TECHNICAL BULLETIN
Bell Helicopter

No. 205-09-125

MODEL AFFECTED: 205

SUBJECT: TAIL ROTOR GEARBOX EXCLUDER HOUSING
LEAK: PREVENTION OF

Figure 1

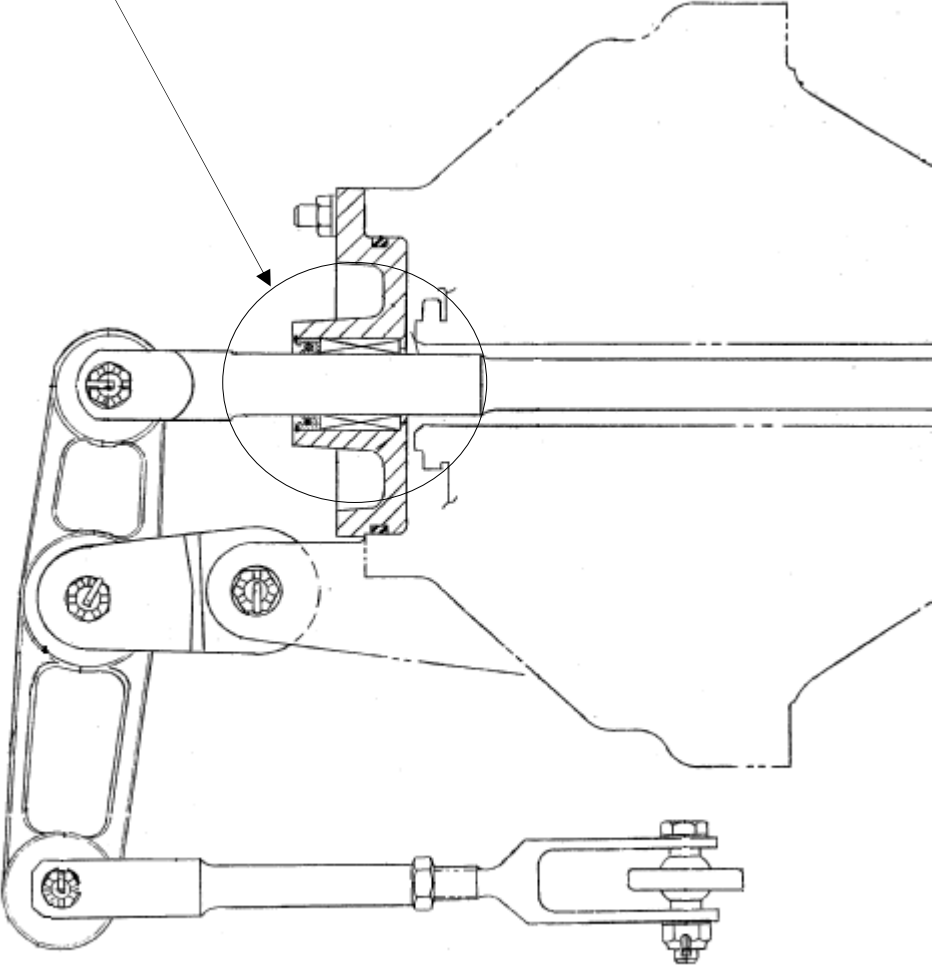
1. Make helicopter ready for maintenance.
2. Refer to Figures 1 and 2. Remove retaining ring (1) and extract excluder housing (2) by applying pressure on the tail rotor controls from full right pedal to full left. (IF excluder and packing need to be replaced refer to BHT-205-MM for disassembly instructions).
3. Using a clean cloth dampened with acetone (C-316) clean inside diameter of pitch change housing (3) where excluder housing (2) will be installed.
4. Using a clean cloth clean outside diameter of excluder housing (2) with acetone (C-316) and coat with sealant (C-328).
5. Install excluder housing (2) in pitch change housing (3).
6. Using a clean cloth dampened with acetone (C-316) remove excessive sealant and reinstall retaining ring (1).
7. Make an entry in helicopter historical records indicating compliance with this technical bulletin.

Figure 2

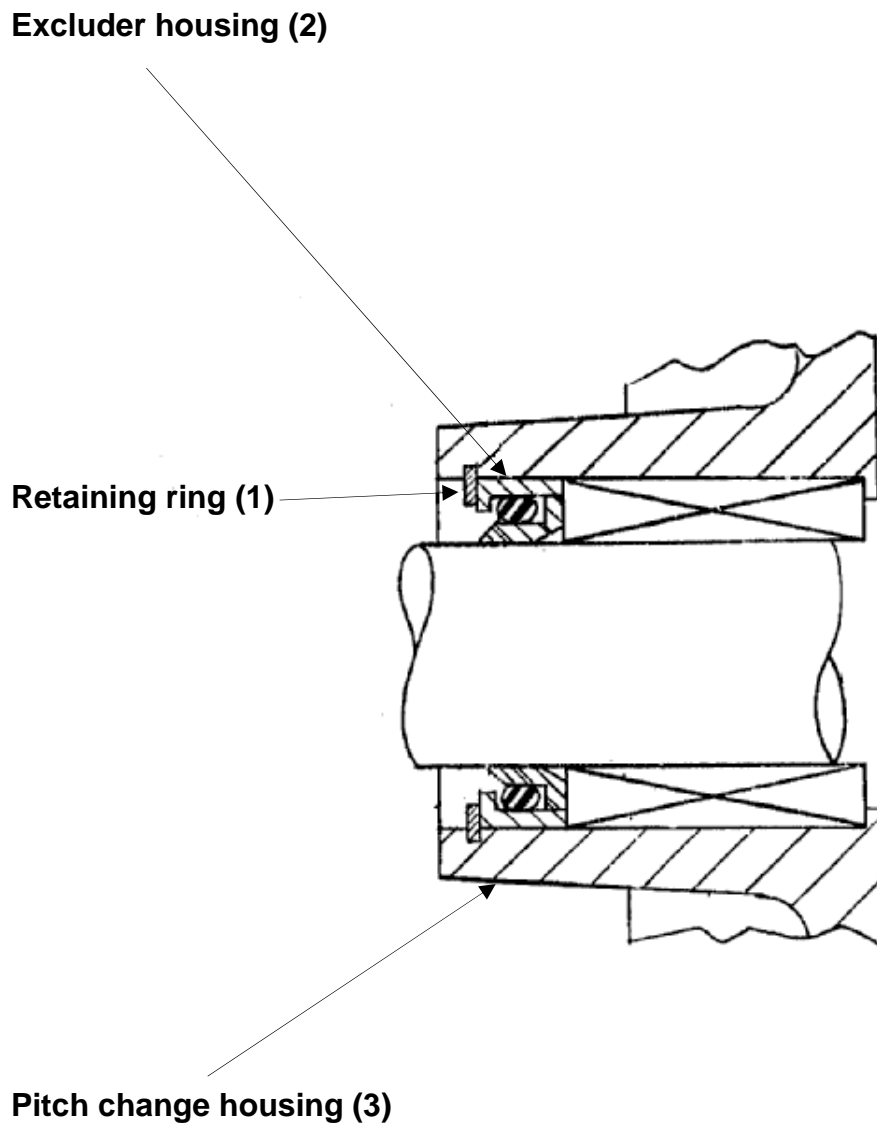
Refer to
Figure 2
